MEMORANDUM TO: Gregory F. Suber, Chief
Low-Level Waste Branch
Division of Decommissioning, Uranium Recovery
and Waste Programs
Office of Nuclear Material Safety
and Safeguards

SUBJECT: TECHNICAL REVIEW: OXIDATION OF REDUCING
CEMENTITIOUS WASTE FORMS, DOCKET NO. PROJ0734

Technical Review: Oxidation of Technetium in Reducing Cementitious Material

Figure 1. Adapted from Langton (2014a) (CBP-TR-2014-0005). Tc leached from samples of Cast Stone exposed to moist soil and deionized water.

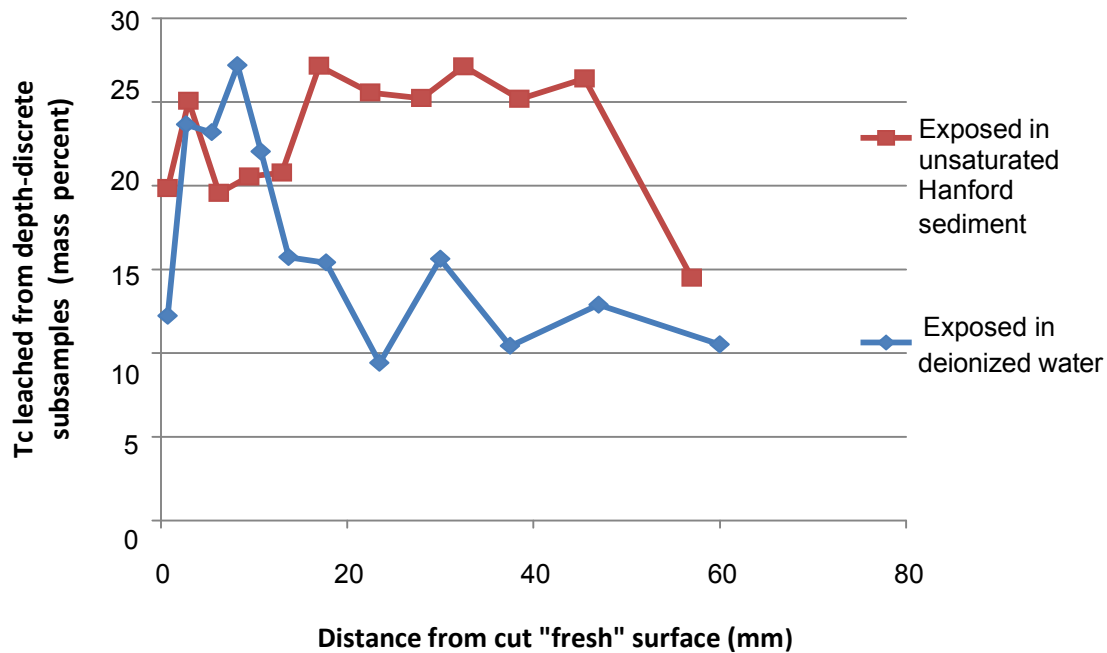
The authors found that soluble Tc was leached from all of the depth-discrete subsamples from both samples (i.e., the sample exposed to deionized water and the sample exposed to moist soil). Although all depths had some fraction of leachable Tc, there was a front that separated areas of relatively more and less leachable Tc (Figure 1). The authors interpreted the

leachability of Tc along the entire length of the samples to suggest that oxygen had penetrated to parts of the entire length of both samples. The authors acknowledged that the small leachable fraction found throughout the sample could be an experimental artifact, because depth-discrete samples were crushed in contact with air prior to leaching. However, the authors also observed that, based on previous experiments (Langton *et al.*, 2012), they would expect less than 5 percent of the Tc to oxidize during sample handling, as compared to more than 10 percent of Tc that could be leached in all of the depth-discrete subsamples.

The authors found that the front of increased Tc leachability extended further into the sample exposed to moist soil than it extended into the sample exposed to deionized water. The authors concluded from this observation that the rate of oxygen migration into the sample exposed to soil was faster than the rate of migration into the sample exposed to water. The authors concluded that this observation was consistent with the more rapid transport of ions through a gas phase as compared to a liquid phase.

Figure 2. Adapted from Langton and Almond (2013) (SRNL-STI-2013-00541). Comparison of Tc-99 fraction leached as a function of distance from the top surface for a 10 day old and a 98 day old (exposed to air) Cast Stone sample.

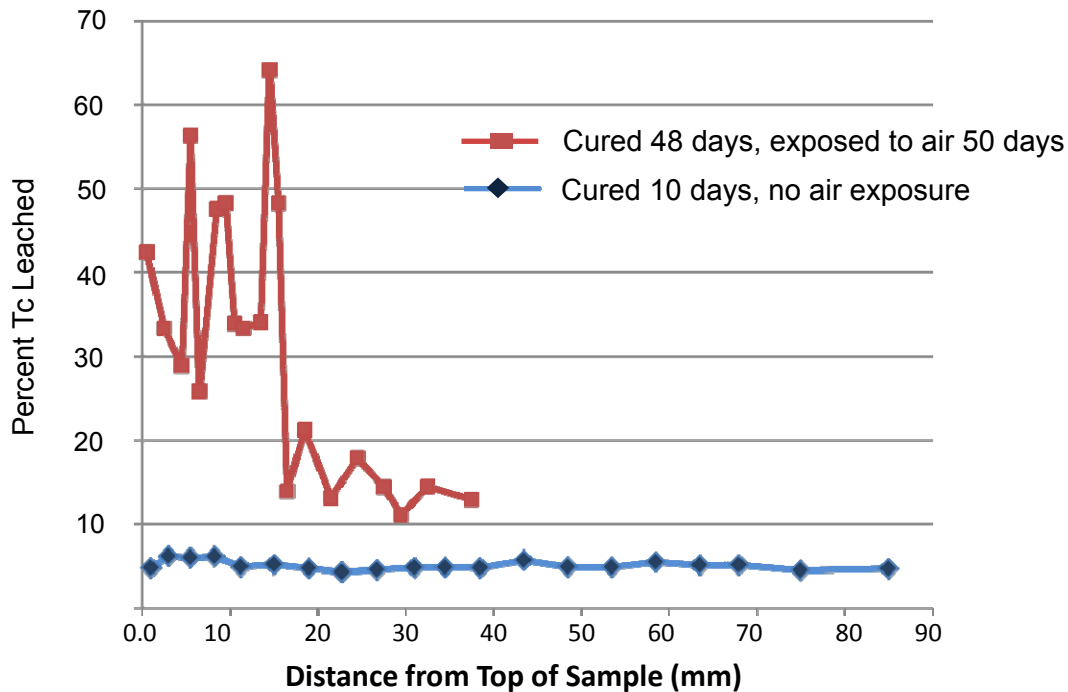
The authors also observed that in the sample cured for 10 days and not intentionally exposed to air, no Tc oxidation front was observed, but 5 percent of the Tc could be leached at each depth (Figure 2). The researchers concluded from this observation that 5 percent of the Tc remained oxidized after 10 days of curing, and suggested that additional testing at longer curing times would be needed to determine whether 100 percent of the Tc(VII) in Cast Stone could be reduced with longer curing times. However, the authors acknowledged that the oxidized fraction could be an experimental artifact because each depth-discrete subsample was crushed in contact with air prior to leaching.

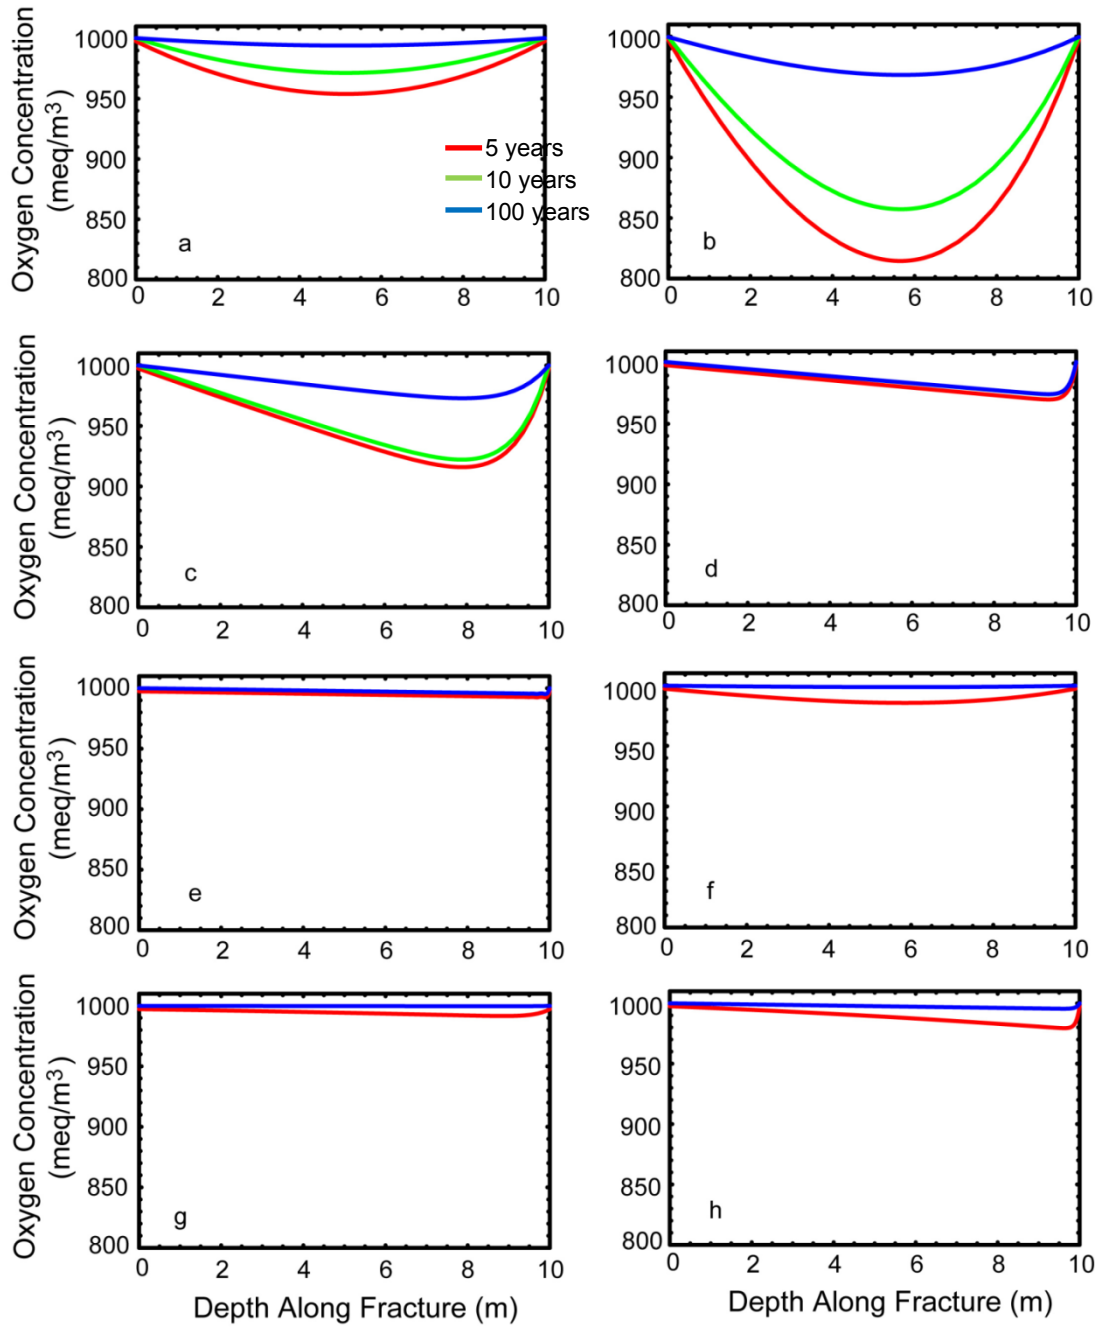
The researchers also evaluated the effects of fracture saturation. As shown in Figure 3, certain assumed fracture characteristics allowed slight depletion of oxygen along the length of the fracture. The authors determined this effect was caused when the amount of water in the fracture, in combination with the size of the fracture aperture, was sufficient to limit diffusion of oxygen from the gas phase, but not sufficient to comparably increase advection of water through the fracture. However, the authors noted that in each case, the oxygen concentrations in the fractures returned to, or very close to, the steady-state concentration in the surrounding soil. The authors concluded this result occurs because oxygen transport in the fracture is fast compared to the diffusive loss of oxygen to the porous grout matrix. One of the central conclusions of the paper is that for a range of fracture characteristics, grout oxidation is limited by the diffusion rate in the grout. In addition, based on the approach to steady-state conditions shown in Figure 3, the authors observed that for the long time frames of interest in performance assessment, gas-phase diffusion and liquid-phase advection in the fractures can resupply the fractures with oxygen from the surrounding soil.

The authors also suggested that because diffusion in the pore space of intact grout material is expected to be the rate-limiting process for grout oxidation, detailed process-level models coupling fracture transport processes with matrix diffusion and chemical reactions are not needed to adequately project grout oxidation. Instead, fractures can represent internal

Figure 4. Oxidation projections based on the model of Painter and Pabalan (2009) and predictions modified for saltstone parameters, including a reducing capacity of 0.607 meq e⁻ / g saltstone, porosity of 0.58, density of 1010 kg per m³, and effective diffusion coefficient of 3.15 x 10⁻⁵ m² / year.

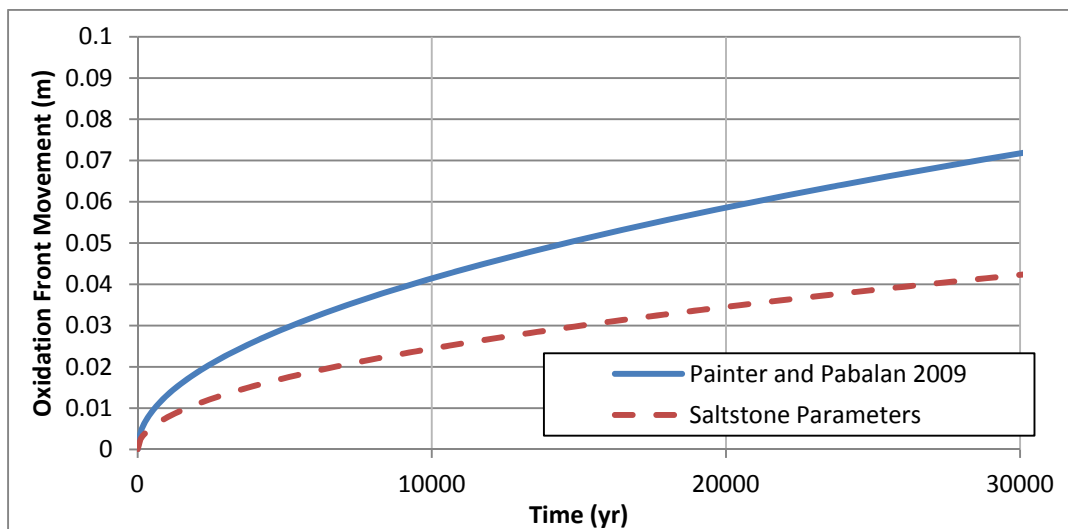
3. Using the value of $0.607 \text{ meq e}^- / \text{g}$ saltstone for the reducing capacity of saltstone assumes all of the measured reducing capacity in saltstone is in a physical form available to reduce Tc (i.e., not obstructed with a passivating layer).

4. Using the value of $0.607 \text{ meq e}^- / \text{g}$ saltstone assumes the amount of oxidation that occurs in the field during field-scale mixing, pumping, and pouring of saltstone in contact with air is adequately represented by the amount of oxidation that occurred during laboratory-scale mixing and pouring of saltstone samples.

The NRC staff is not aware of studies specifically designed to quantify oxidation that occurs as saltstone is mixed, pumped, and poured in contact with air. DOE has plans to measure Tc leaching from cored samples of field-emplaced saltstone. Comparing leaching from field-emplaced saltstone and laboratory-created samples may capture some effects of oxidation during field emplacement if the cores are partially oxidized. However, reducing capacity is more likely to affect the duration of reducing conditions than it is to affect Tc leaching from areas that remain reducing. Because the oxidation state of a redox couple depends on the Eh of solution, and not the reducing capacity, Tc leaching is not necessarily a good indication of whether some, but not all, of the reducing capacity in a region of saltstone has been consumed. Thus it is not clear whether measurements of Tc leaching from reduced regions of saltstone will adequately support conclusions about how much reducing capacity is consumed by mixing, pumping, and pouring saltstone in contact with air. Because the reducing capacity is a chemical barrier to oxygen ingress, studies that evaluate the progress of an oxidation front could provide information about the effective reducing capacity of field-emplaced samples. Measurements of reducing capacity also could be useful, if they address the uncertainties related to reducing capacity discussed in this review.

In addition to the limitations of the projections of Painter and Pabalan (2009) discussed above, a more fundamental limitation exists if Tc leaching is not well correlated to residual reducing capacity. This question is discussed further in the evaluation of Question 4.
